REVISED RESPONSE TO REQUEST FOR ADDITIONAL INFORMATION

APR1400 Design Certification

Docket No. 52-046

RAI No.: 227-8274
SRP Section: 03.08.04 – Other Seismic Category I Structures
Application Section: SRP 3.8.4
Date of RAI Issue: 09/25/2015

Figure 1 Static Lateral Pressure

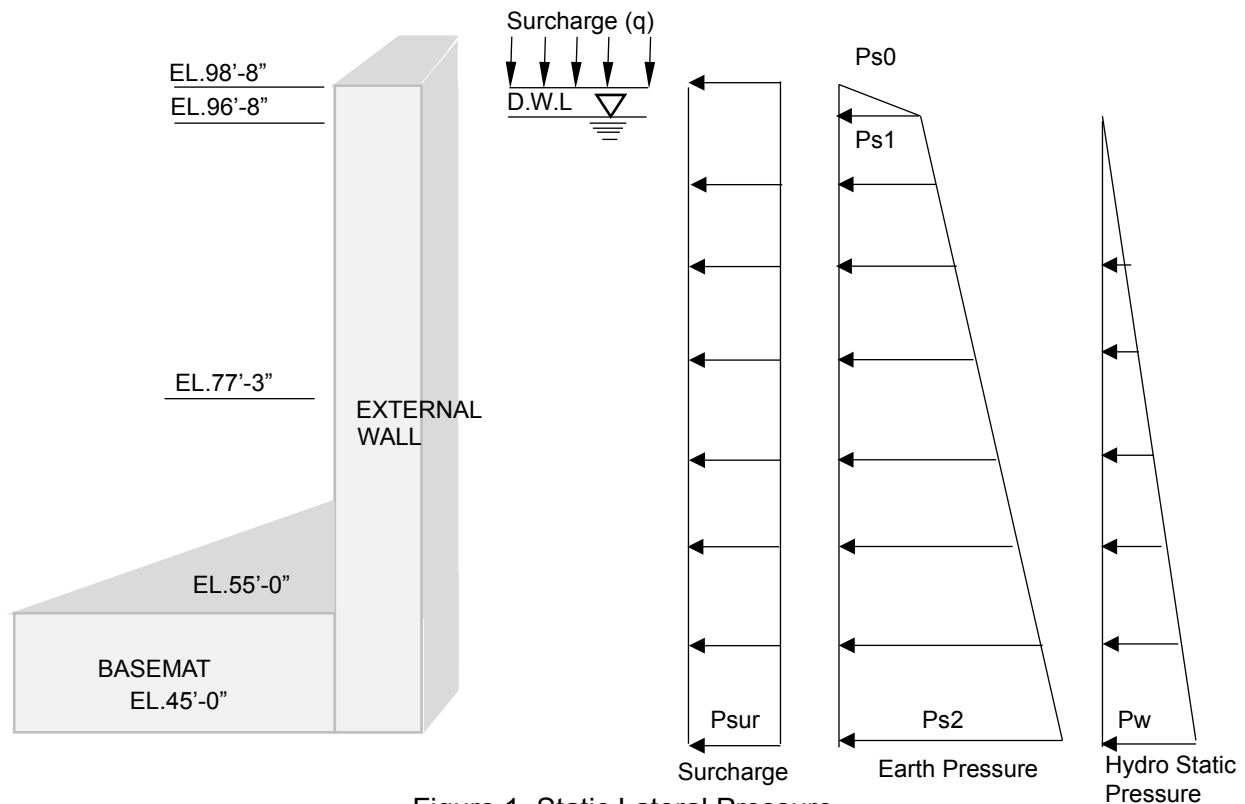
Applicant is requested to describe how the various water/flood related loads are classified (e.g., normal, severe environmental, abnormal, etc.), how they are calculated in terms of the loads used in DCD Section 3.8.4, how are they applied in the design of seismic Category I structures,

Hydrostatic loads are calculated as a linearly distributed pressure on external walls depending on the design water level (EL. 96'-8") according to the basic equation of hydrostatics as shown in Figure 1. The design groundwater elevation for the APR1400 standard plant design is based on the EPRI ALWR URD (Utility Requirement Document) Table 1.2-6 "Envelope of ALWR Plant Site Design Parameter". Therefore, the maximum design ground water level is determined to be 0.61m (2 feet) below the plant grade in the vicinity of the SSSc important to safety. Please see the applicant's response to RAI 75-8023 Question No. 03.04.02-1 item a.(ii).
